37/3-96HH 107 Elm Avenue  
(Takoma Park Historic District)

HISTORIC PRESERVATION COMMISSION STAFF REPORT

Address: 107 Elm Avenue

PROPOSAL: Replace roof, gable window, attic windows.

3<sup>RD</sup> FLOOR WINDOW  
FRONT GABLE  
107 ELM AVENUE  
TAKOMA PARK, MD 20912

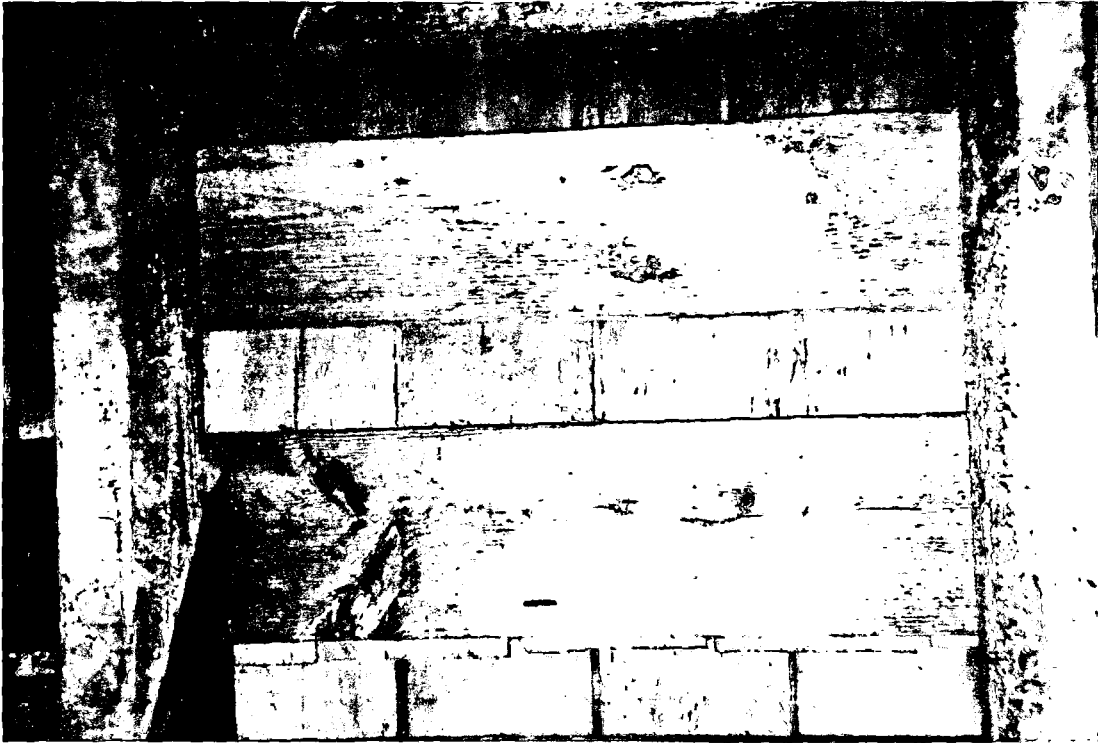
The proposal to modify the attic windows is based on window treatments seen on the twin house at 105 Elm Avenue. The current pediment window is a storm window installed on its side in the original opening. The proposal of paired double-hung 1/1 windows would enlarge the original opening, but staff concurs with applicant's plan to bring more light into the attic while keeping the design in close to identical configuration with the house next door. Staff understands that modifications to one house of a pair do not necessarily justify them being made to the other house. For instance, the use of wood siding on 105 Elm Avenue would not justify replacement of the fishscale and stucco siding on 107 Elm Avenue. Where repairs are required, however, it is appropriate to look to the twin for design ideas which are in keeping with the style of both houses.

PROPOSED FRONT ELEVATION  
(PARTIAL)

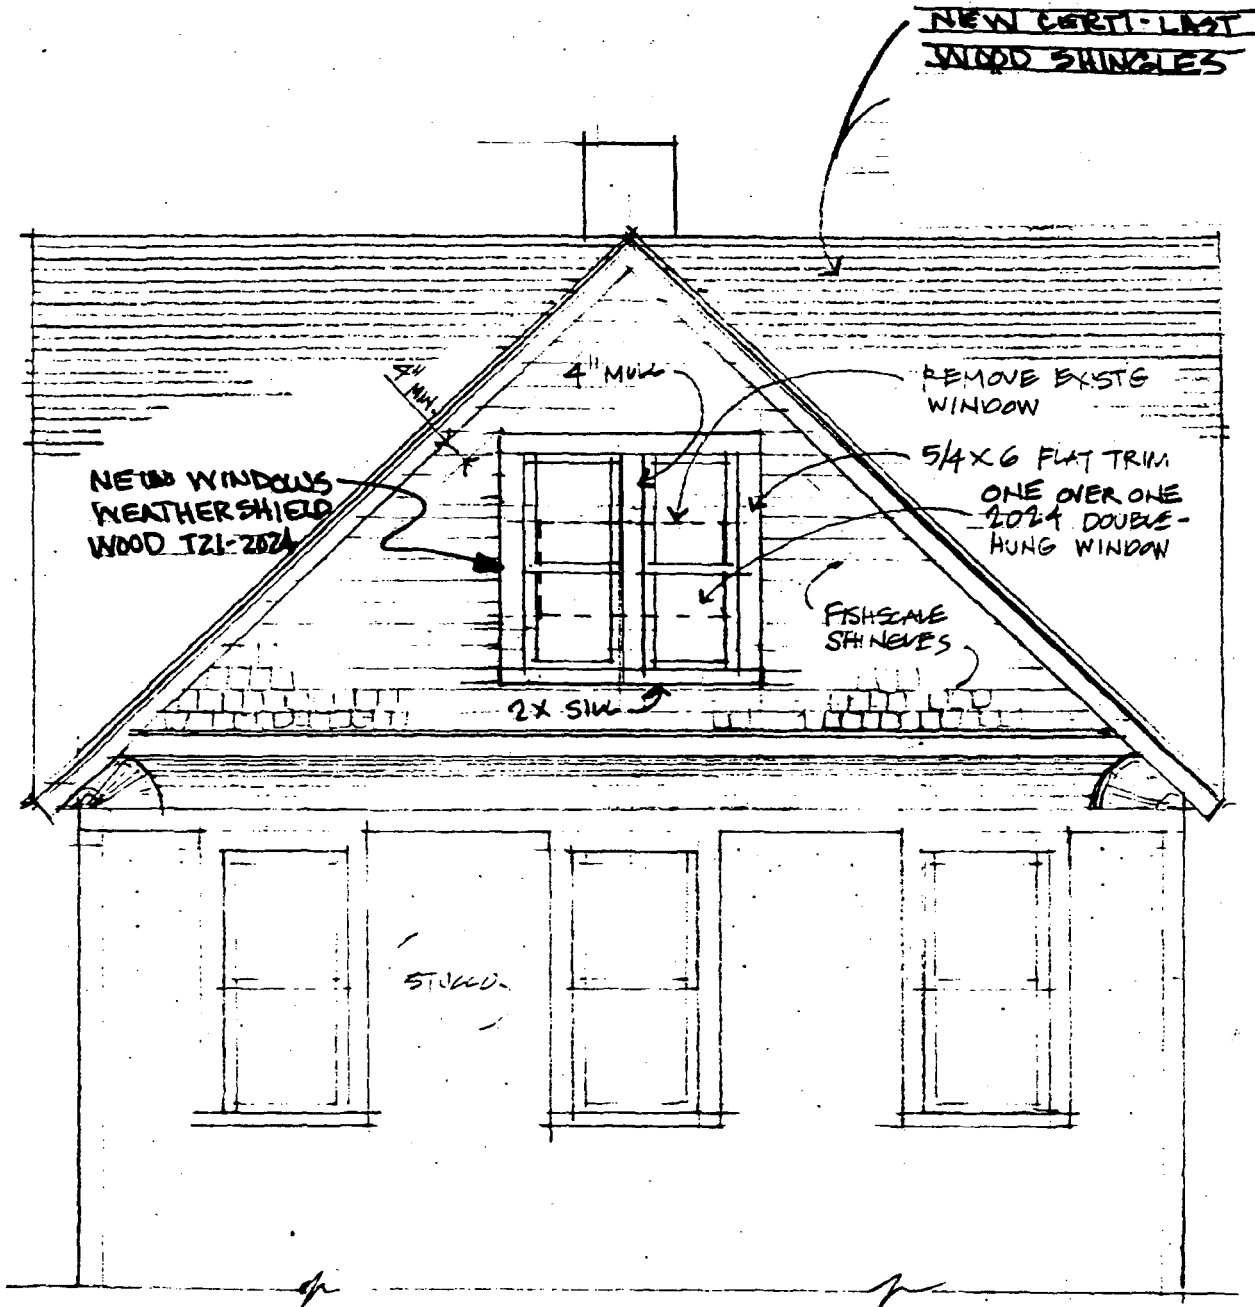
The roof modification proposed by the applicant is based on evidence that the replacement materials would be duplicating original material. Remnants of wood shingles and skip sheathing can be seen under the existing metal roof. Staff supports the proposal to return to wood shingles using pressure-treated material.

PROPOSED REAR ELEVATION  
(PARTIAL)

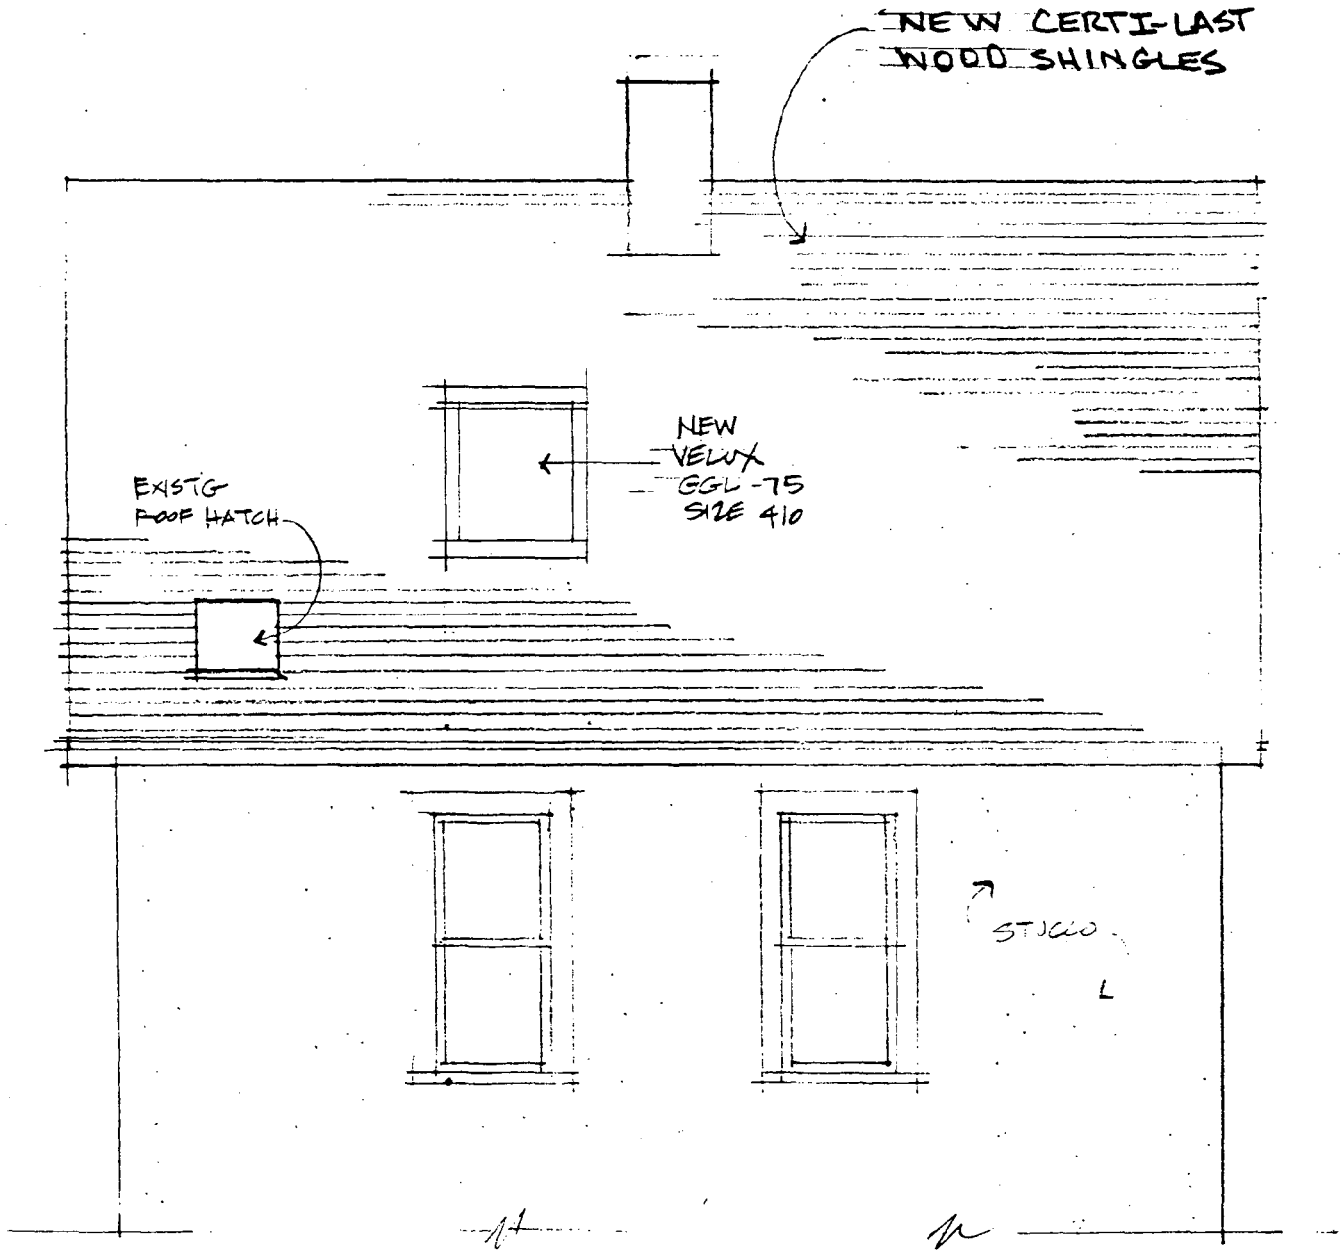
Staff supports the proposal to install a skylight when the roof is replaced as the light is in the rear and would not be visible from the side or front of the house.
